RDE GTR Structure

Open Points (JRC)

2. Data consistency checks (Altitude and Ambient temperature)

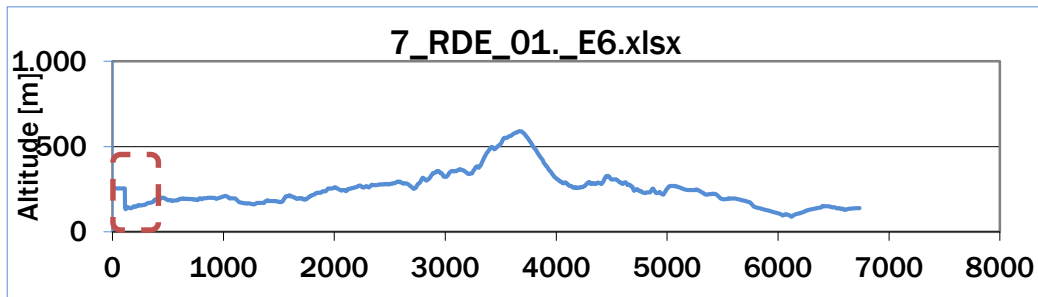
- Altitude signal is smoothed and outliers are eliminated during the calculation of the cumulative altitude gain.
- Problems occur very often at test start, when the GPS is not active.
- As a consequence, the GPS altitude value at test start (see example below) are false and can lead to significant errors in the calculation of the cumulative altitude gain.
- **Proposal 1: Provisions in the text are sufficient for the GPS altitude. Currently, we encounter only limitations in their software implementation.**
- **Proposal 2: It is suggested to add a sentence to remove the outliers for the ambient temperature, as they may lead to the undesired application of the extended factor for some data points.**

- **CONSISTENCY CHECK OF VEHICLE ALTITUDE**
In case well-reasoned doubts exist that a trip has been conducted above of the permissible altitude as specified in point 5.2 of this Annex and in case altitude has only been measured with a GPS, the GPS altitude data shall be checked for consistency and, if necessary, corrected. The consistency of data shall be checked by comparing the latitude, longitude and altitude data obtained from the GPS with the altitude indicated by a digital terrain model or a topographic map of suitable scale. Measurements that deviate by more than 40 m from the altitude depicted in the topographic map shall be manually corrected and marked.
